DART SERVICE INSTRUCTION

TO AMEND INSTALLATION INSTRUCTIONS IIN-D076-612 REV. A

REF. CANADIAN STC: SH94-38 ISSUE 2 REF. FAA STC: SR00298NY

VIEW OF FIGURE 5 (DETAIL 'C') of IIN-D076-612 Rev. A

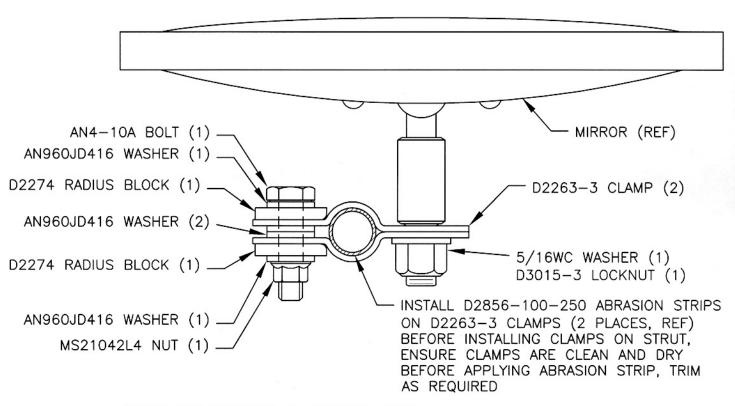
For the D076-612-015 CHG 002 Cargo Mirror kit, the **D2011-103** Mirror referenced in IIN-D076-612 rev.A has been replaced with the **D3439-101** Mirror Assembly. The attaching hardware for this mirror has been changed to reduce the chance of slippage in flight. The mirror should be installed per the figure on page 2 of this document. The parts list for the D076-612-015 Cargo Mirror kit is given below.
